FINAL INITIAL STUDY/MITIGATED NEGATIVE DECLARATION FOR THE ESTRELLA SOLAR PROJECT

Los Angeles County Department of Regional Planning 320 West Temple Street, Room 1348 Los Angeles, CA 90012 Contact: Soyeon Choi 213-974-6443

ICF 525 B Street, Suite 1700 San Diego, CA, 92101 Contact: Mary Bilse 858-444-3972

September 2021

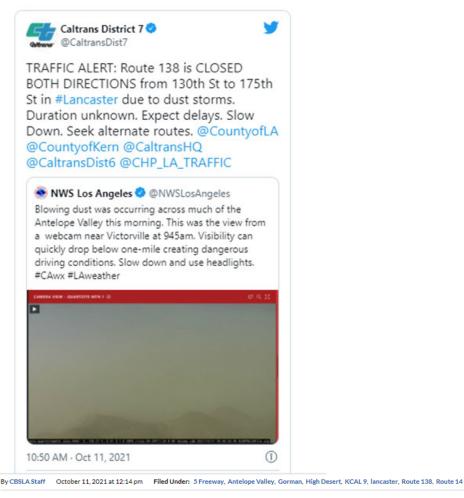
Thank you for your response, however it is baffling. Are you saying that there are no mitigation measures for dust control from project operations in the CEQA document for the Estrella project, but the project will be conditioned to eliminate dust impacts from operations anyway? On what basis? Your environmental document did not even consider dust impacts from operations. The AV communities have tried over and over to get DRP and other agencies to mitigate the dust problems caused by operation of the 50,000+ acres of solar farms that have been approved in the AV thus far, yet no agencies ever do. I fear residents have just given up. According to County Health statistics, the Antelope Valley has the highest childhood asthma rates IN THE STATE and the highest COPD rates IN THE COUNTRY. Yet, DRP and other agencies persistently ignore the cumulative dust impacts of adding still more solar farms without any dust mitigation measures other than the occasional "submit a dust plan to the AVAQMD". You are advised that AVAQMD Dust Plans do nothing to control dust from solar farm operations; they simply require the property owner to post signs that direct the public to call a phone number if dust is observed. By the time the inspector arrives (hours later), the dust event is over. And, if you think I am overstating the problem, please consider the fact that, just three days ago, the dust problem was so bad in the AV that both the 14 freeway and the 138 highway were closed because of "zero visibility" conditions. Here are some photos:

Dust is a terrible problem in the Antelope Valley and it is substantially exacerbated by all the solar farms that DRP and other agencies keep approving without adequate dust mitigation measures. When is the County and other agencies going to start caring about AV residents? Jacqueline Ayer Utilities Committee Chair
